Re: Director of Public Works Approval of Non-standard Streets at the Ford Site

Map Attachment to November 5, 2019 Letter from Director of Public Works re: Non-Standard Streets at the Ford Site Page 1 of 2 (Markup NTS)

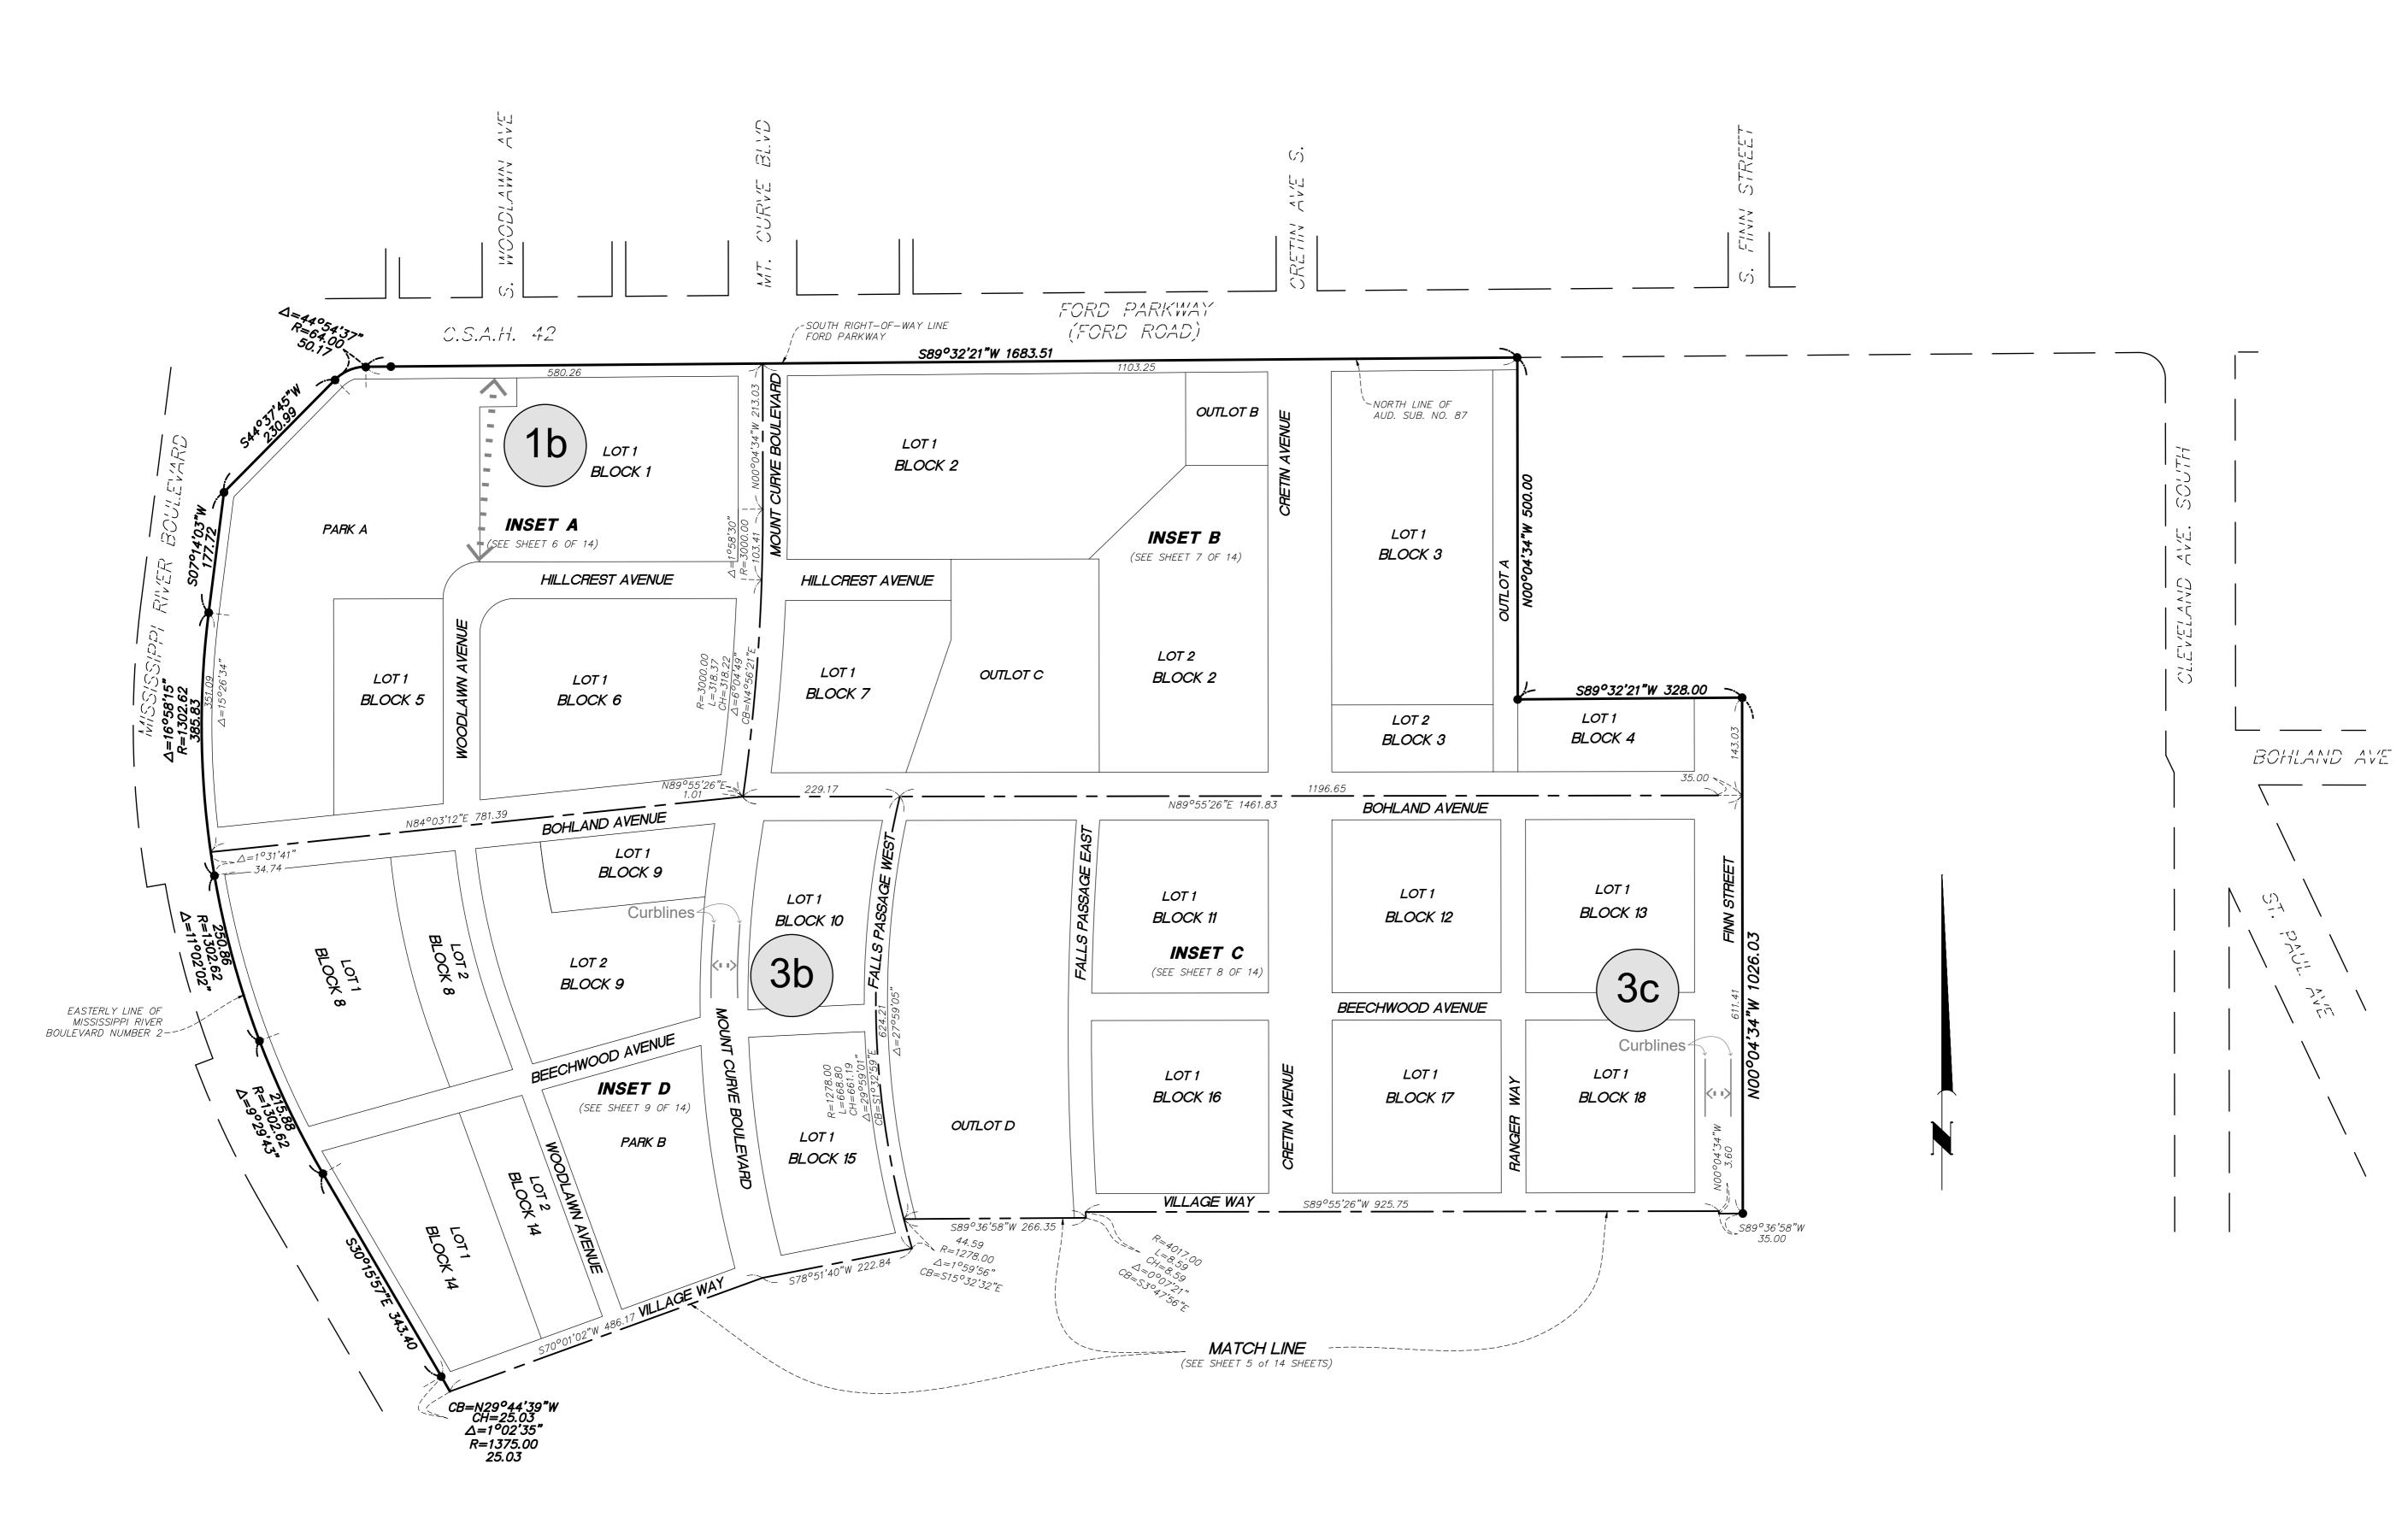
- a. Saunders Avenue does not continue across Cleveland Avenue into the site.
 - i. Reasoning for modification: The environmental review evaluated traffic patterns without the presence of a Saunders Avenue connection between Finn Street and Cleveland Avenue and determined that Montreal Avenue was sufficient for traffic flow. In addition, by not building Saunders in this area, the Highland Little League fields could be maintained a priority for the Parks and Recreation Department and the neighborhood.

- b. Woodlawn Avenue does not connect to Ford Parkway in the north end of the site.
 - i. Reasoning for modification: The relatively short distance of approximately 180' from the merge point of northbound access from Mississippi River Boulevard to a potential intersection of Mount Curve Boulevard would increase the potential for traffic impacts considering the high volume of vehicular traffic eastbound on Ford Parkway.

- c. Yorkshire Avenue does not continue across Cleveland Avenue into the site.
 - i. Reasoning for modification: the piece of the Ford property between proposed Montreal Avenue and the Canadian Pacific property is an odd shape and features significant topography challenges that would create significant development challenges, especially considering the uncertain future of the Canadian Pacific property. Access from Montreal on the north will serve the parcel.

- a. The segment of Montreal Avenue west of Cretin Avenue has a right-of-way width of sixty-two feet (62').
 - i. Reasoning for modification: there is no on-street parking on Montreal Avenue and the traffic volumes are not anticipated to be high enough to warrant the addition of a turn lane.

- 3. Collector roadway width minimum is thirty-six feet (36').
 - a. The segment of Montreal Avenue west of Cretin Avenue has a roadway width of twenty-six feet (26')

- Reasoning for modification: In addition to not having on-street parking on this segment of Montreal Avenue, the bike lanes have been separated from vehicular traffic and are now behind the curb, reducing the curb-to-curb width.

Eleven-foot (11') vehicular travel lanes are provided in addition to a two-foot (2') reaction zone on both sides.

- b. The segment of Mount Curve Boulevard between Bohland Avenue and Montreal has a roadway distance of thirty-two feet (32').
 - Reasoning for modification: Bike lanes have been separated from vehicular traffic and are now behind the curb, reducing the curb-to-curb width. There are two travel lanes and on-street parking in this segment.

- c. Segments of Bohland Avenue and Finn Street have a roadway distance of thirty-two feet (32').
 - Reasoning for modification: Bike lanes have been separated from vehicular traffic and are now behind the curb, reducing the curb-to-curb width. There are two travel lanes and on-street parking in these segments.

- 4. Local street right-of-way width minimum to be defined by the Director of Public Works
 - a. Reasoning for modification: The attached map shows local streets as determined by Public Works staff and the master plan. Staff has evaluated refinements of master plan sections and with the understanding that there may be adjustments necessary for things like utilities and turning movements, the right-of-way widths shown in the plat are acceptable.

- 5. Utility Location unless waived, all utility facilities...shall be located underground and within the street or alley right-of-way.
 - a. Reasoning for modification: The plat shows utilities located under what will be a private alley. Easements have been shown on the plat for these utilities, and they have been reviewed by Public Works staff. Any future utilities under private property will require similar review and easement(s).
